**GREATER HARTFORD TRANSIT DISTRICT
GHTD IFB #07-025
ROOF DRAIN LINE REPAIR
AT HARTFORD UNION STATION**

ADDENDUM #1

April 18, 2025

At "GREAT HALL CHASE DETAIL" on Dwg A-01, add the following to the "1 LAYER 5/8" TYPE X GYPSUM WALL BOARD" callout:

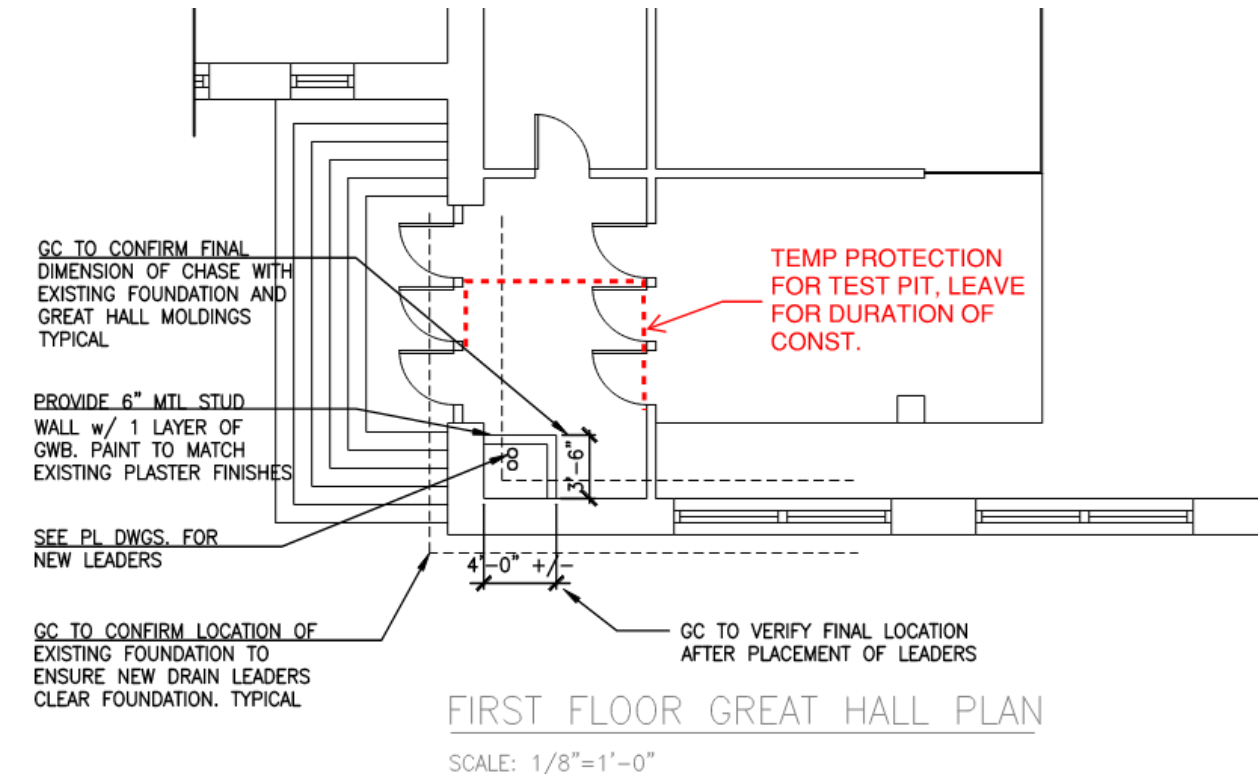
Noise Mitigation and Chase Insulation:

- RC-1, 1/2" RESILIENT CHANNEL HORIZ AT 16"o.c. OVER 1ST LAYER OF GYPSUM BOARD (GWB)
- SECOND LAYER 5/8" TYPE "X" GWB OVER RESILIENT CHANNEL
- 4" MINERAL WOOL SOUND ATTEN. INSULATION - FIT WITH WIRE STAYS AT BACK OF STUD TO HOLD IN PLACE

All notes pertaining to the Gypsum wall board assembly on the architectural set shall be updated to reflect the wall construction noted above.
